TOWN OF PAONIA
FRIDAY, APRIL 30, 2021
PLANNING COMMISSION MEETING AGENDA
1:00 PM

Mattingly - Clark's End Variance Application

SUBJECT: MATTINGLY – CLARK’S END ROAD VARIANCE

Re: Variance request for grade increase at South Clark Subdivision cul-de-sac

CLARK AVENUE PLAN & PROFILE
C3.0

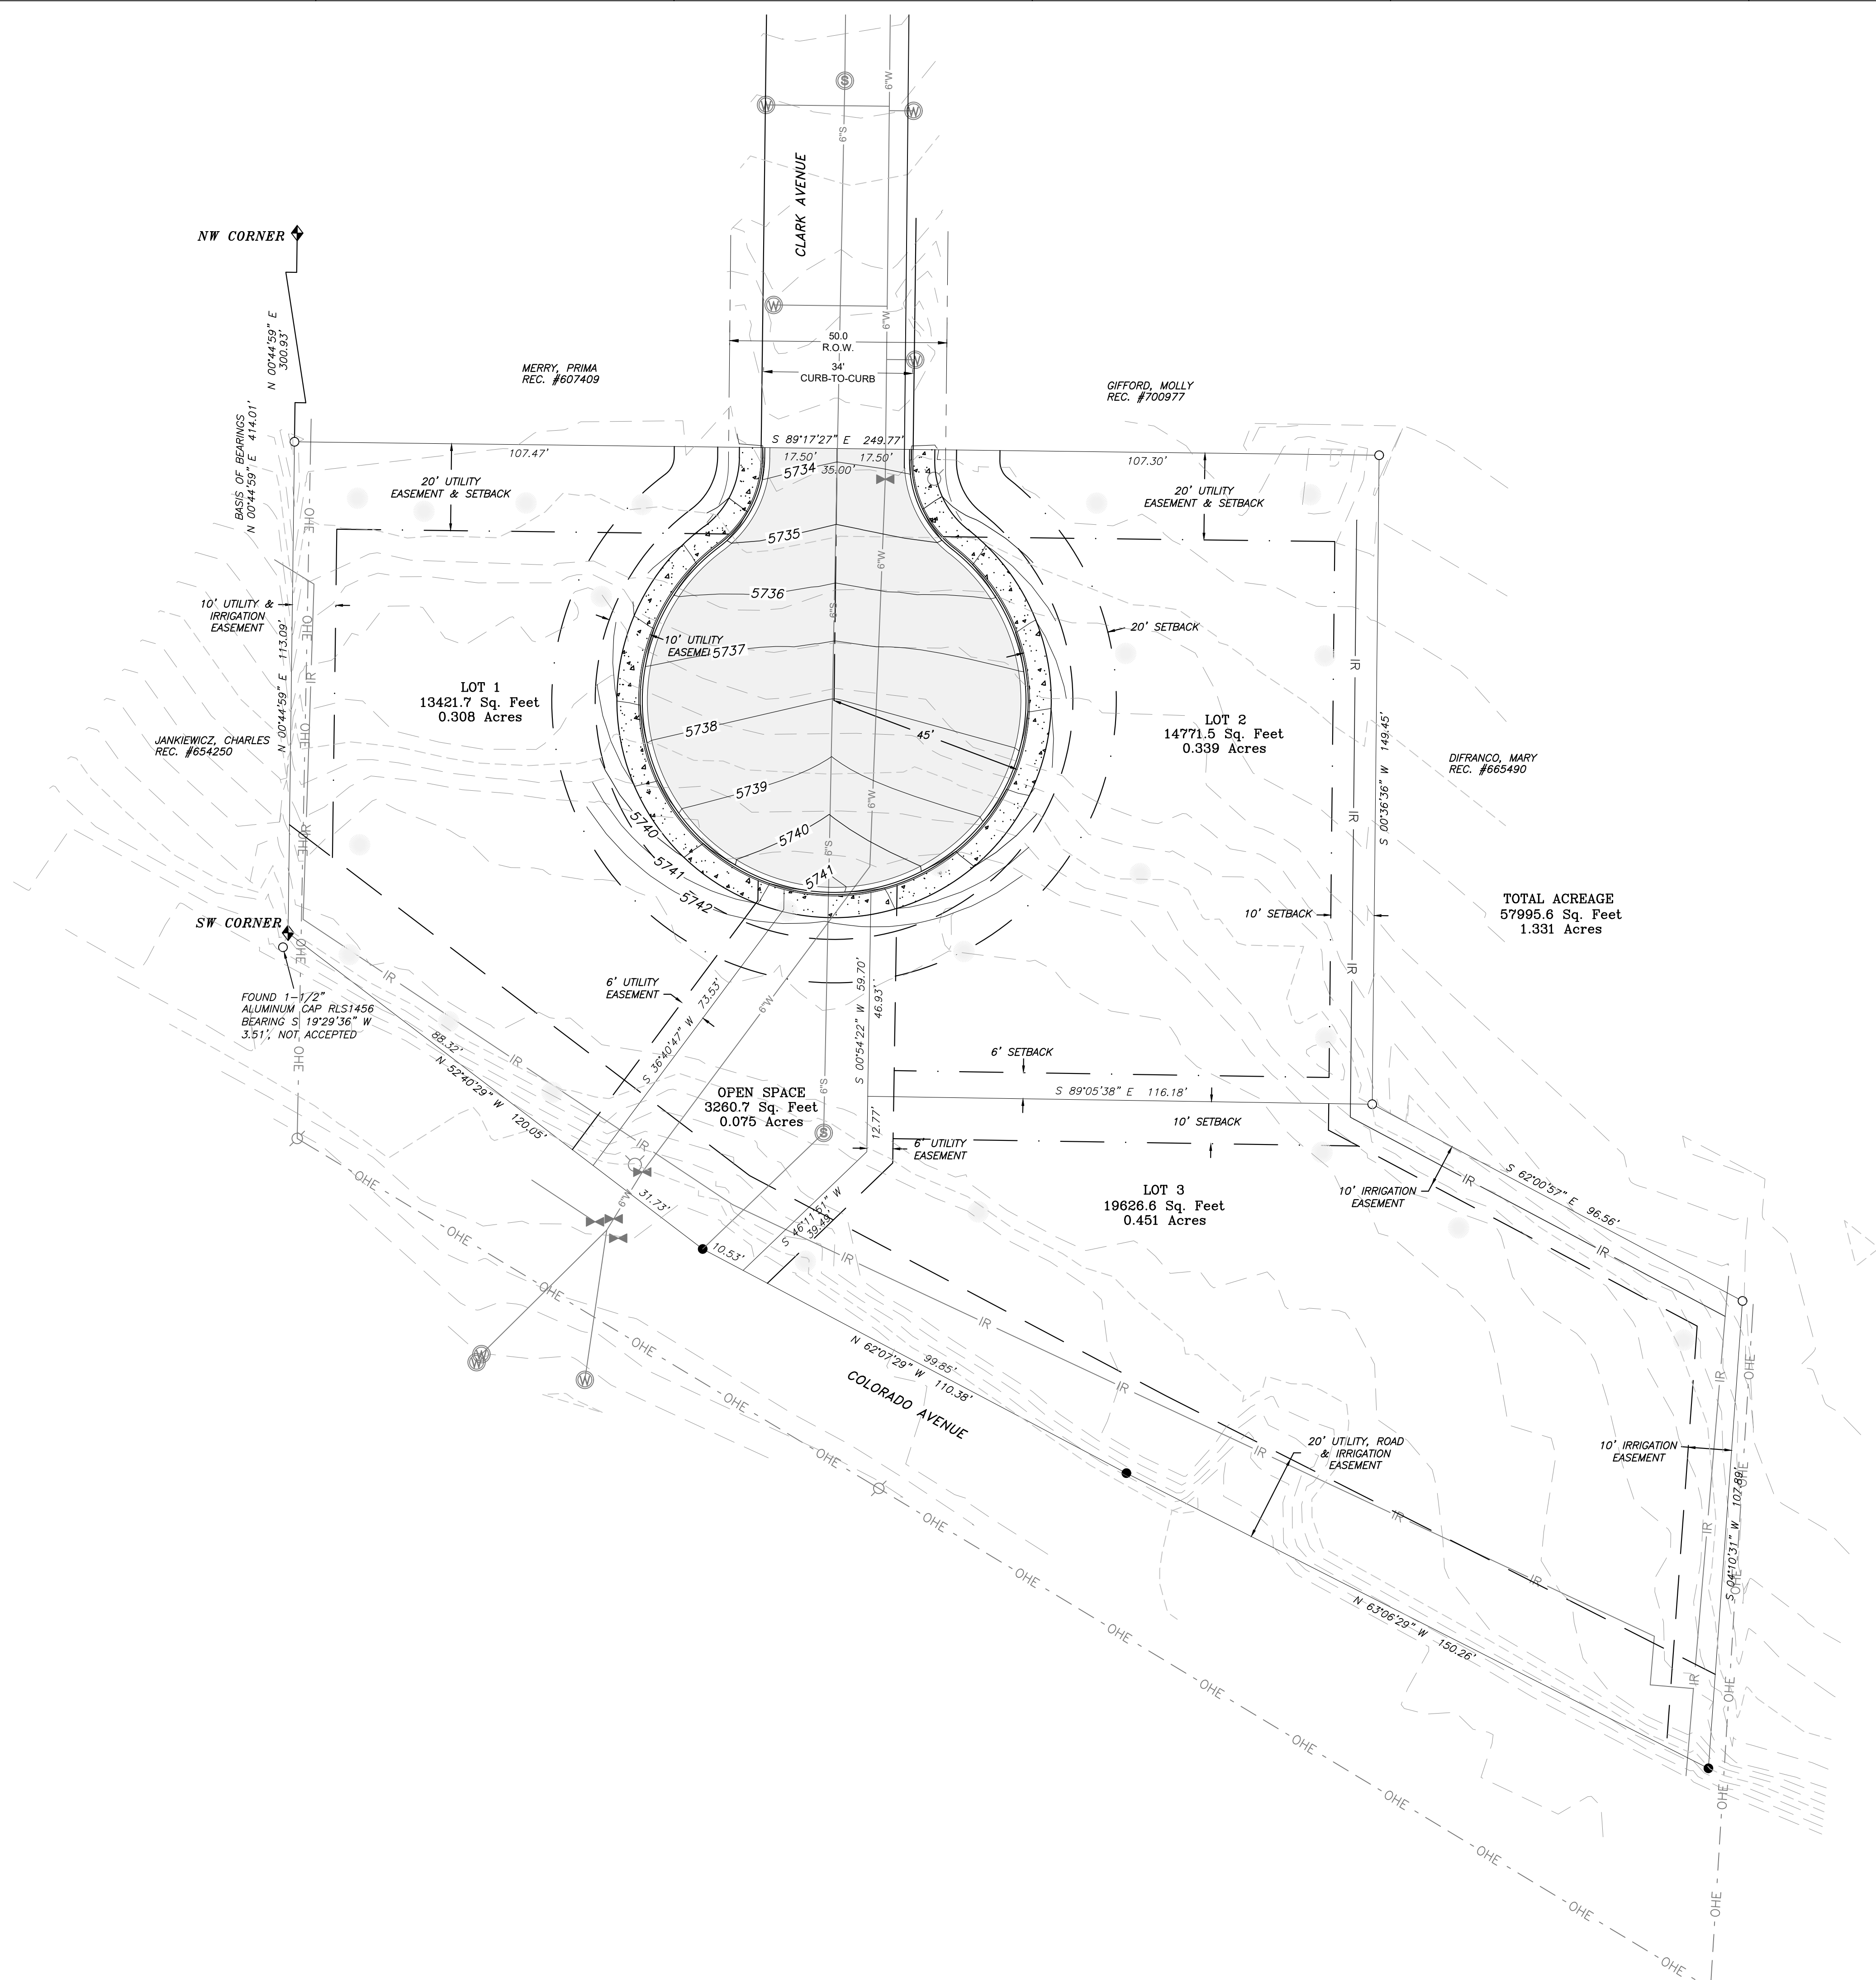
As part of our submittal of construction documents for the subject project, and on behalf of Lynn Mattingly, we are requesting a variance to the maximum allowable slope of the cul-de-sac at the south end of Clark Avenue as described below.

Upon final design of the cul-de-sac we gathered invert elevations of the existing sewer pipe and as-built plans of the water line under South Clark to determine the proposed cover over those utilities. This information is now shown on our latest submittal of the construction plans for this project.

Based on the proposed cul-de-sac profile, we are proposing to increase the slope of the cul-de-sac to 7.50%, which exceeds the maximum allowable slope of 7.00%. By doing so we are maintaining the existing minimum cover over the sewer line on South Clark, which appears to be approximately 4 feet from stations 0+15 to 1+30 on our plans. By increasing the slope to 7.50% we are at or above 4 feet of cover everywhere and therefore do not believe replacing the existing sewer and water lines under the cul-de-sac is necessary.

We are assuming that the water line was installed at a depth of six feet, as noted on the as-built plans provided by the Town. We will be reducing its cover by 6" to one foot for approximately 30 feet in length near the top of the cul-de-sac. Similar to the sewer line, we do not believe this reduction in cover warrants a full replacement of the water line under the proposed cul-de-sac.

Having reviewed and confirmed all requirements and information provided, it is my recommendation to the Planning Commission and Board of Trustees the approval of Clark’s End Subdivision cul-de-sac variance request:

The Street Layout portion of chapter 18 defines the maximum grade for any street to be 7%. Due to the location of the updated water and sewer lines installed by the Town, the applicant requests a variance of .5% to increase the grade of the cul-de-sac to 7.5%. This variance is recommended as to facilitate the installation of the approved cul-de-sac and avoid any disturbance of the Towns infrastructure. Following review it is my opinion the variance request meets the prerequisites for granting variances as provided below.
